Protecting the Sovereignty of the Kalispel Tribe in the Pend Oreille River Temperature TMDL

Presentation to EPA Headquarters

July 24, 2012 • Washington D.C.

Comparison of temperatures under existing and natural conditions at the upstream end of the Kalispel Tribe's reservation (River Mile 72)

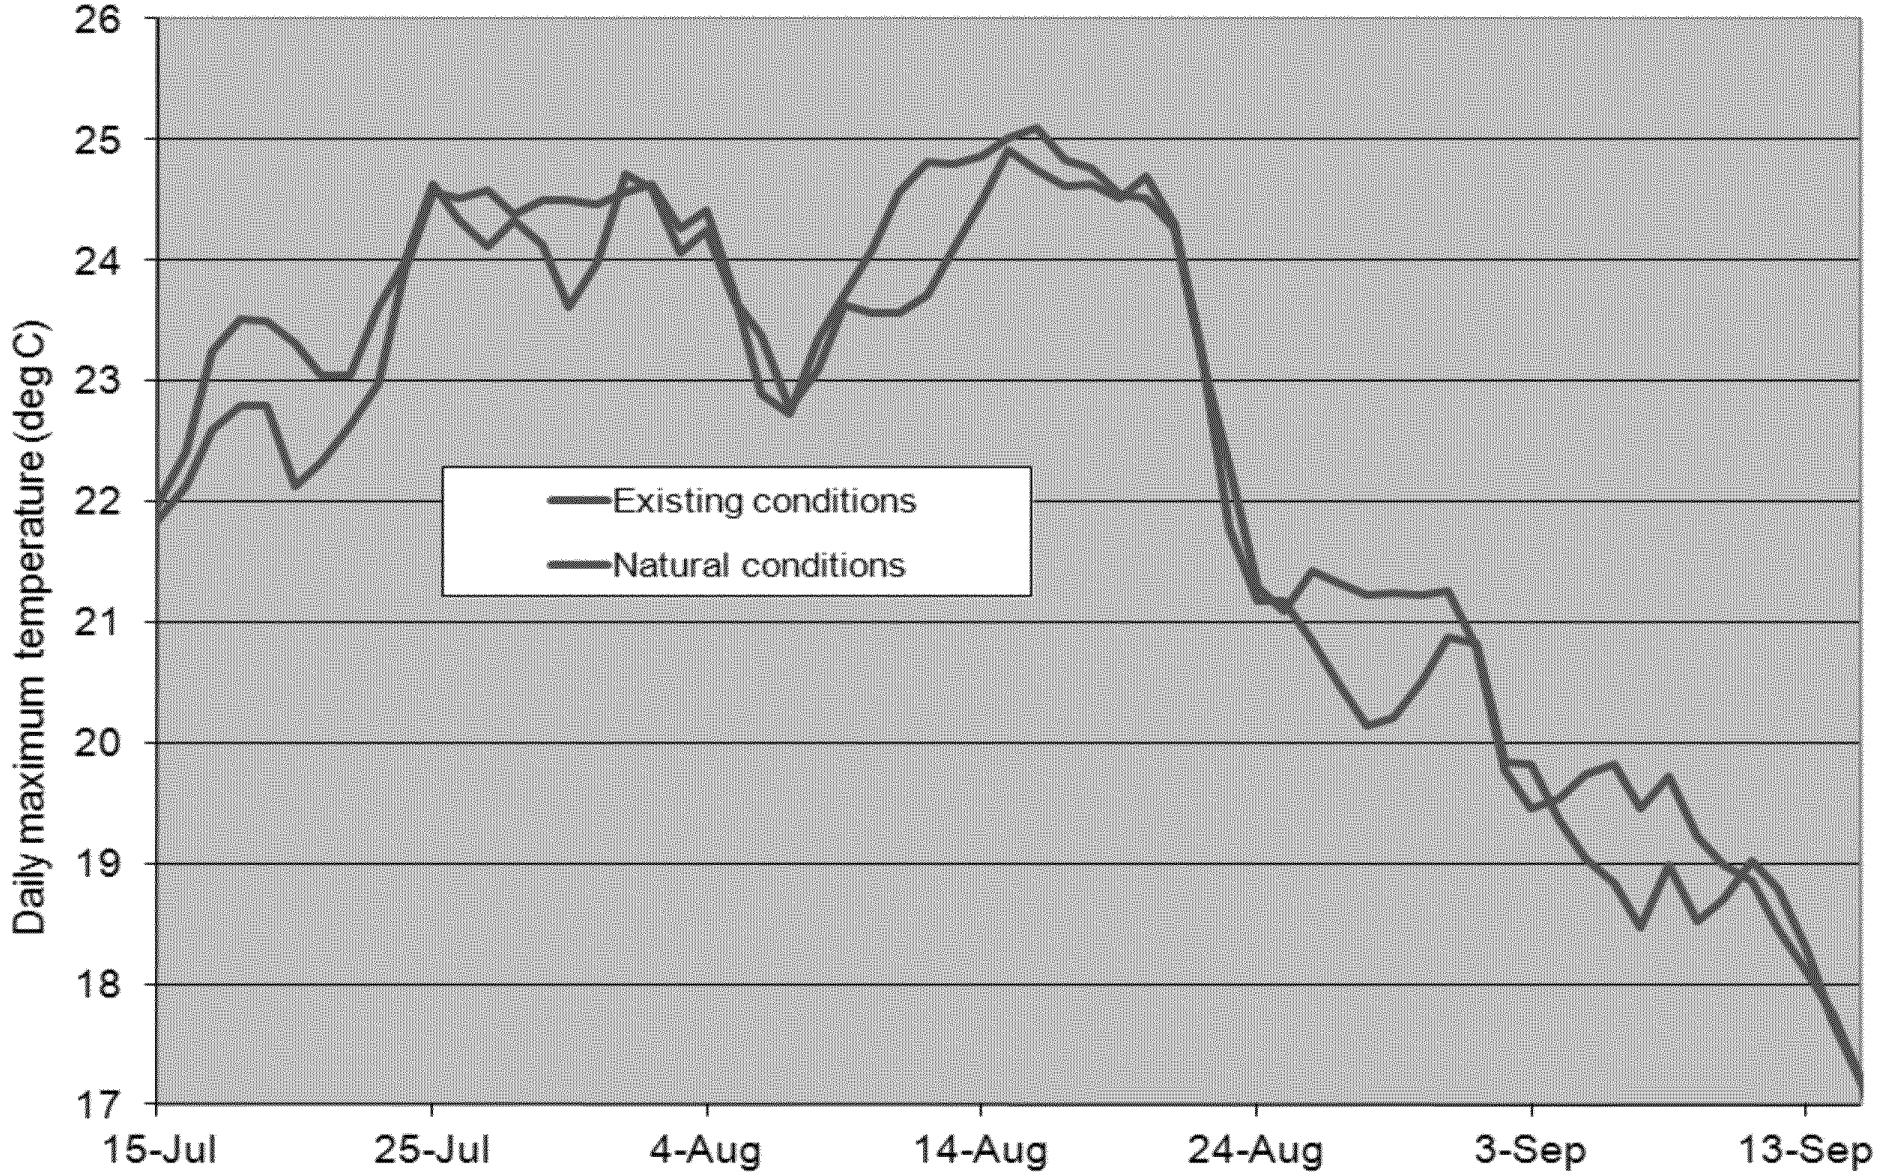
* CFA is necessary to account for time lag
  * Next slide shows that there is no significant time lag
  * Even if time lag were an issue, the pooling period does not correspond to the lag
    * The selected remedy for the lag (93-day CFA) is grossly disproportionate to a time lag that is on the order of days according to Ecology, and at most 1 day on tribal waters
